CONSTRUCTION PLANS FOR WALTON OAKS

CITY OF ROCHESTER HILLS, OAKLAND COUNTY, MICHIGAN

Site Plan Review
Reviewed for compliance with City Ordinance, Building and Fire Codes
Conditions and mark-ups noted throughout plan set must be addressed prior to final approval

Landscape Plan North

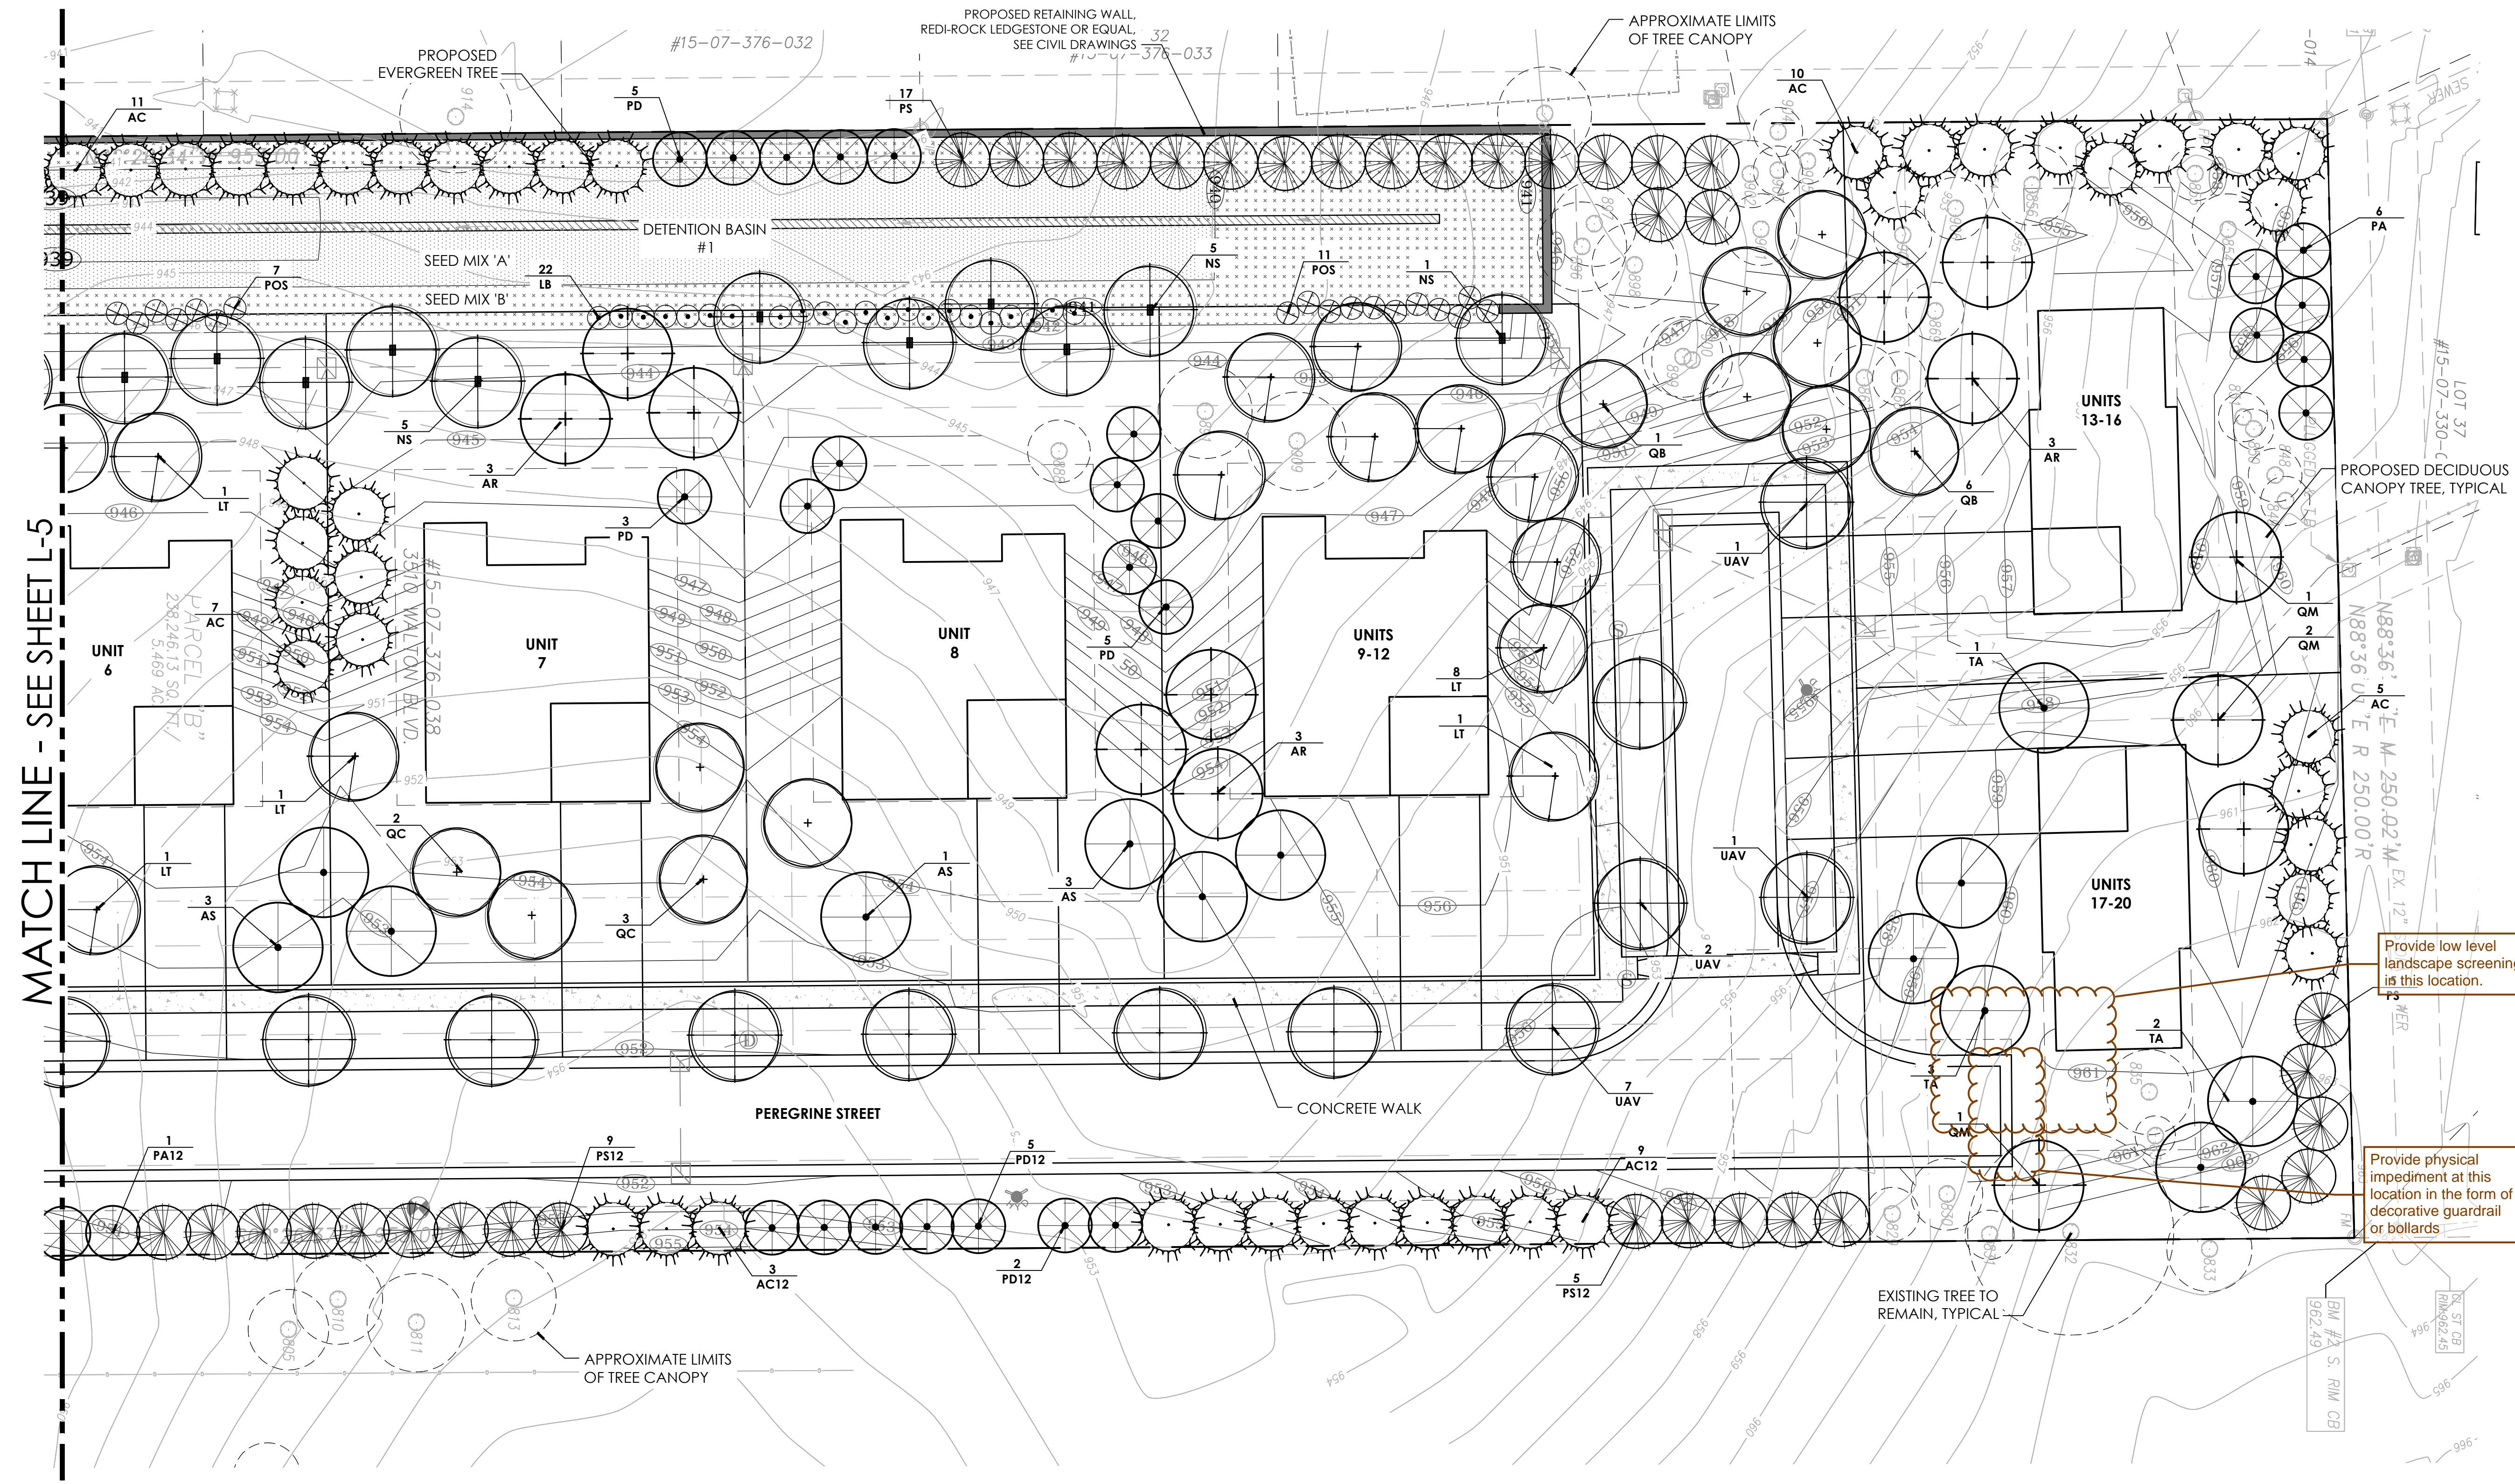
Provide low level landscape screening in this location.

Provide physical impediment at this location in the form of decorative guardrail or bollards.
